*Comments from Mr. HCC
on 2/17
to R Rice/ord.*

Settlement of the Diesel Generator Foundations and Building
(Insufficient Compaction in Plant Area Fill Related to
Seismic Category I Structures and Facilities)

INTERIM REPORT 7

PROJECT: Consumers Power Company
Midland Plant Units 1 & 2
Bechtel Job 7220

MIDLAND POWER PLANT
 TANK FARM INVESTIGATION

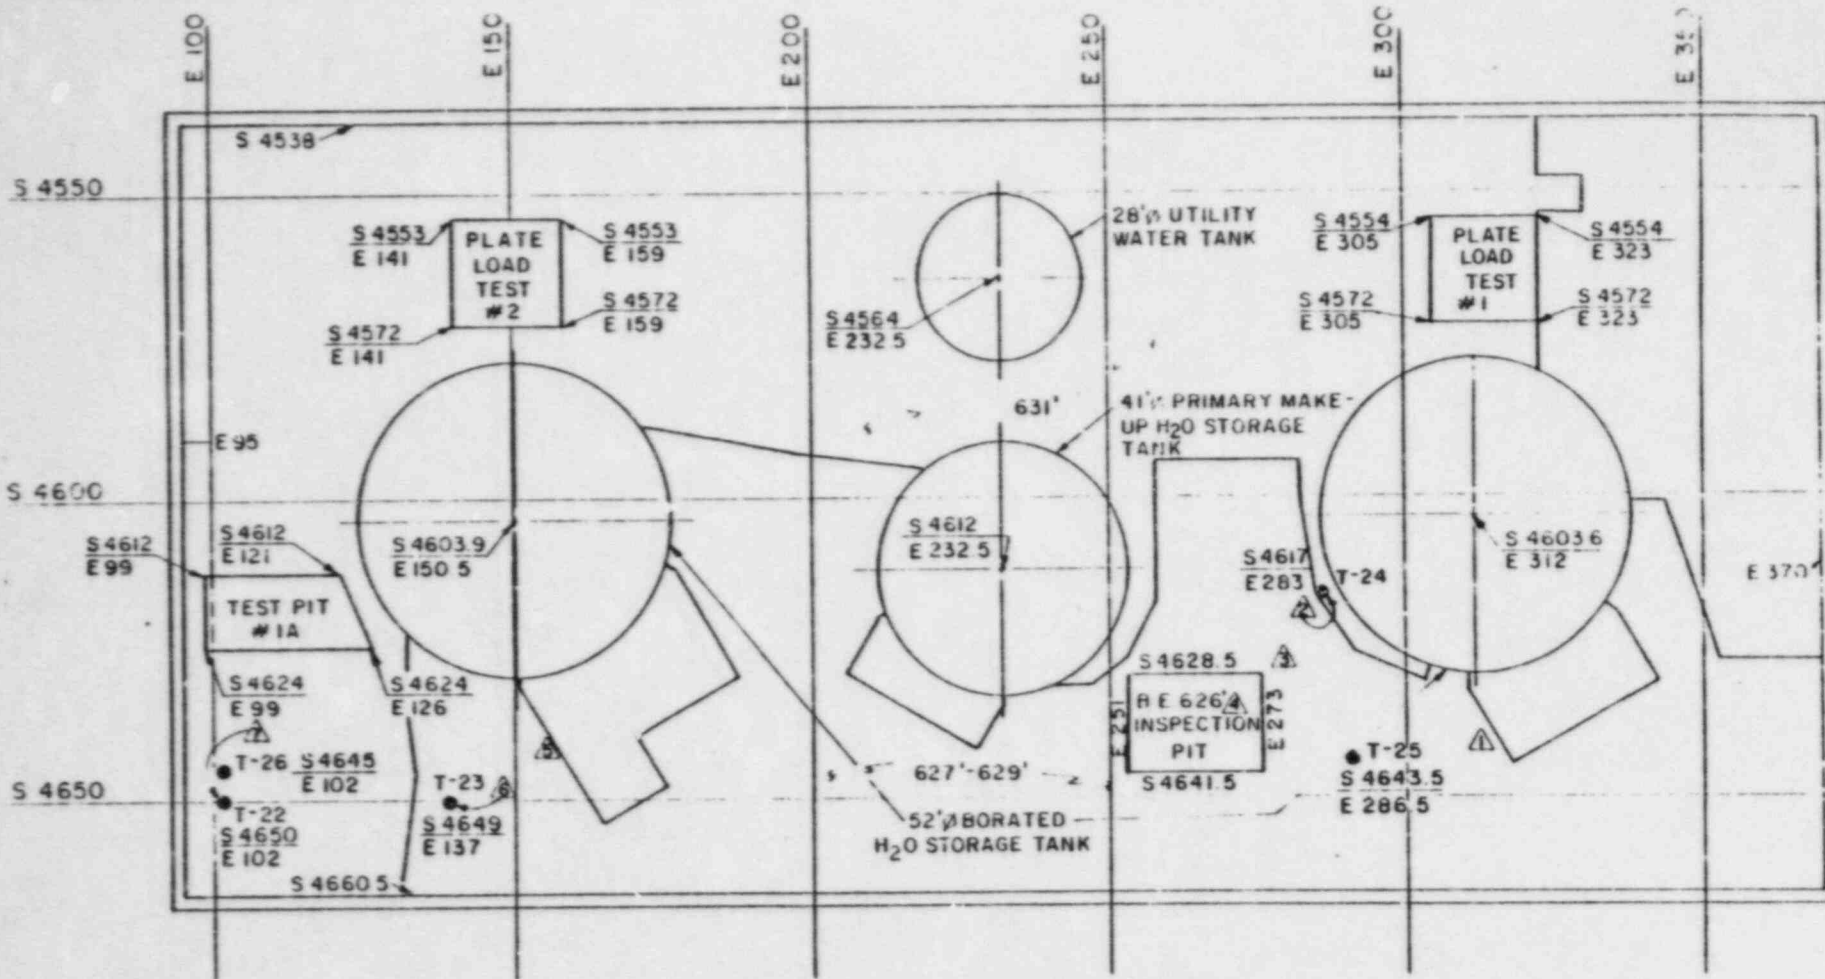
do we want
to keep
making this
compromise?

where? AS
